South Texas Project
Units 1 and 2
Docket Nos. STN 50-498, STN 50-499
Responses to DSER/FSAR Items
Regarding Pipe Break Analysis

Further clarification concerning break exclusion zone criteria, which is pertinent to DSER item 3.6-1, are contained in the attached markups of FSAR pages which will be incorporated in a future FSAR amendment. The Additional revisions enclosed reflect the elimination of arbitrary intermediate breaks (AIB's) including the feedwater system AIB's.

Attachment 1

PIPE BREAK EXCLUSION
ZONE FOR MAIN STEAM
(TYPICAL)

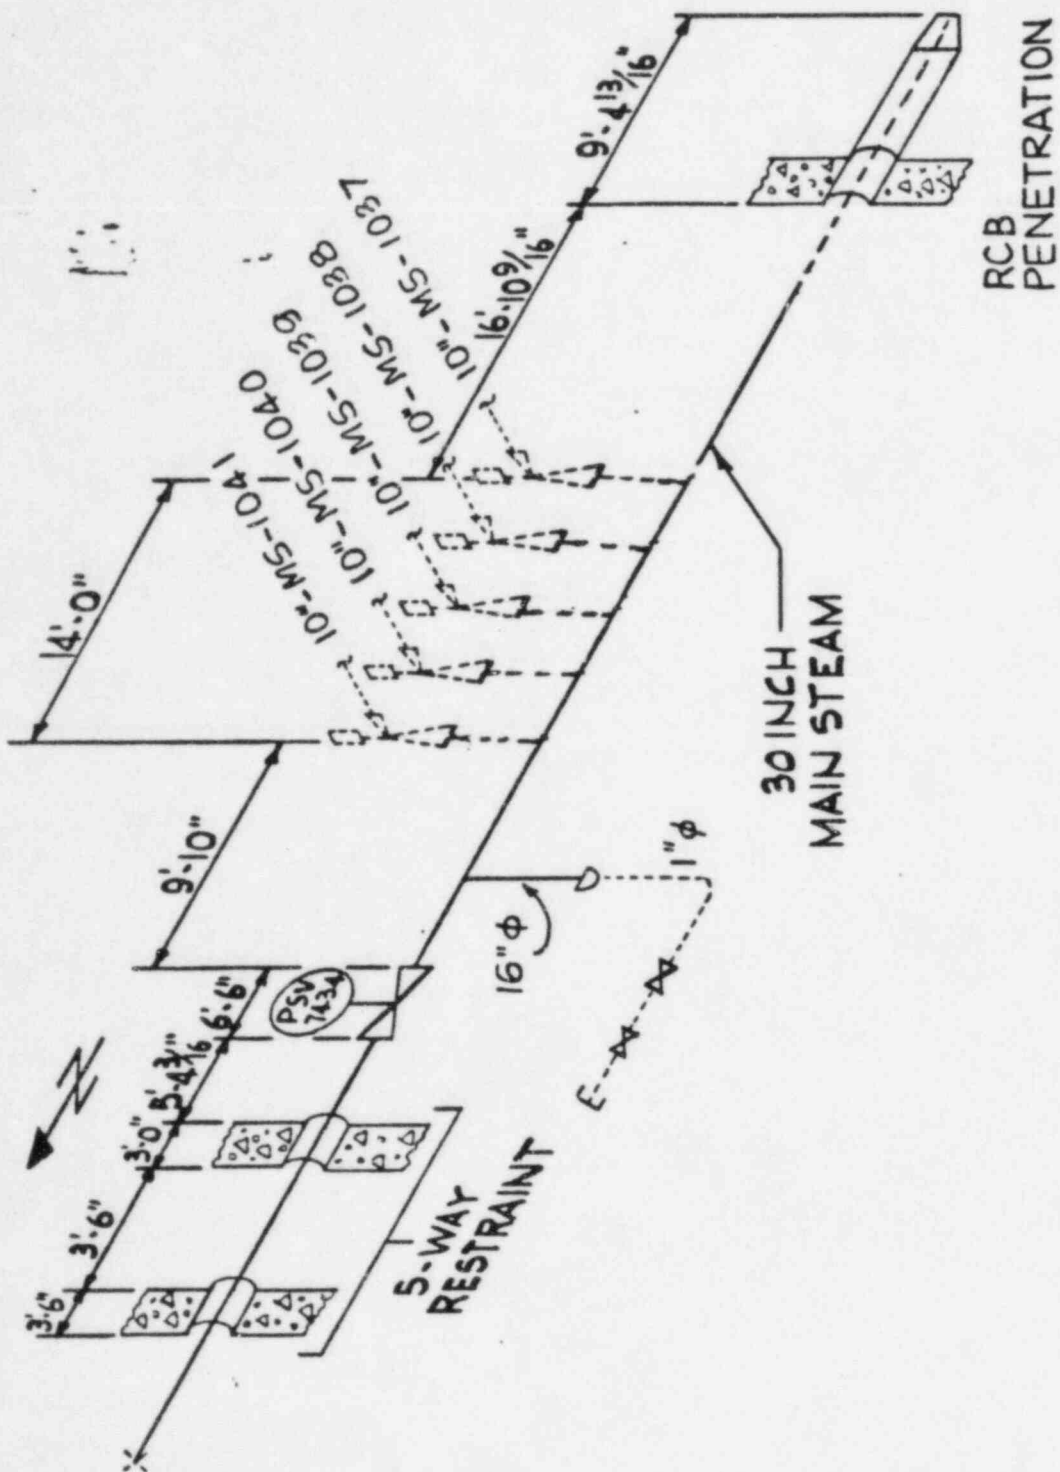
The only lines that are designated as "break exclusion zones" are the main steam and feedwater main runs in the isolation valve cubicle (IVC) as shown on Figures Q210.33-1 and 2. The break exclusion area extends from the containment penetrations through the five-way restraints at the IVC north walls. The only branches ~~included are the safety relief valve lines and~~ the short 16 in. diameter stubs for main steam drain and instrumentation.
